# **MEMORANDUM**

Site Plan Review

820060060

5500 Edson Lane/Peace Palace

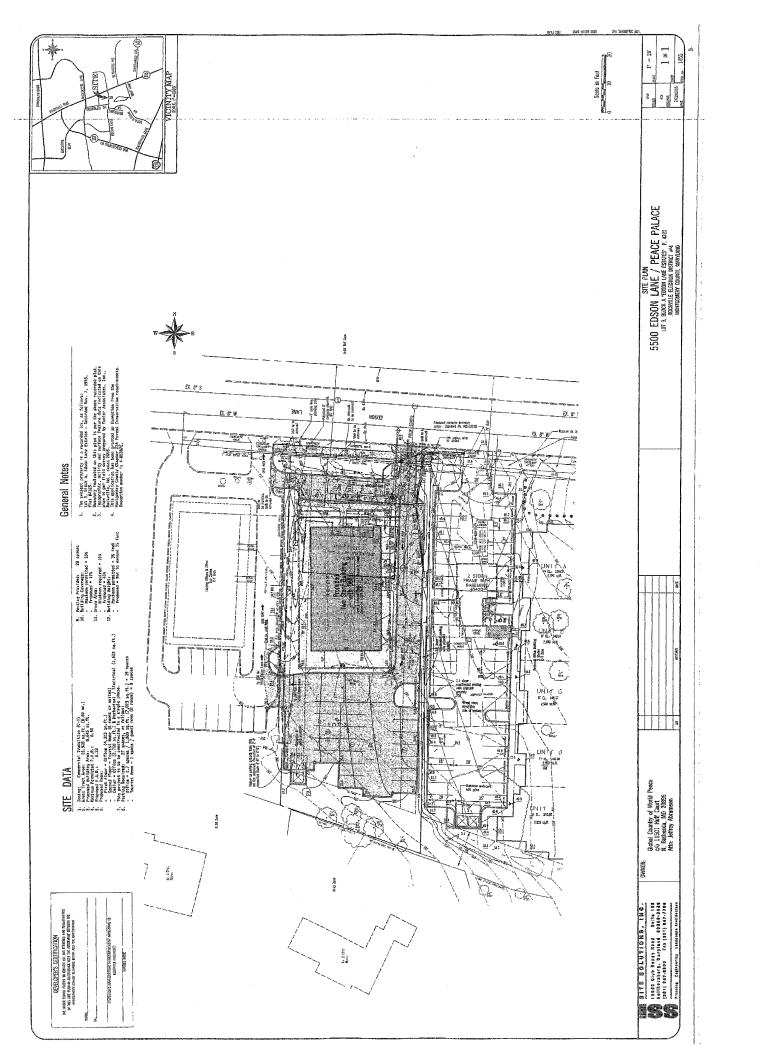
- a. Relocate the dumpster enclosure internally within the parking facility.
- b. Provide a detail of the proposed decorative water feature.
- c. Provide a detail of the proposed building identification sign and locate the sign outside of the public utility easement.

- a. Provide a lighting distribution and photometric plan with summary report and tabulations to conform to IESNA standards for residential development.
- b. Illumination levels shall not exceed 0.5 footcandles (fc) at any property line abutting adjacent residential properties.
- c. The height of the light poles shall not exceed 4 feet including the mounting base.

- a. Provide a five-foot-wide sidewalk and 5-foot-wide lawn panel along the Edson Lane property frontage.
- b. Provide a minimum 4-foot-wide sidewalk from the eastern portion of the proposed parking lot to the five-foot-wide sidewalk within the Edson Lane right-of-way.
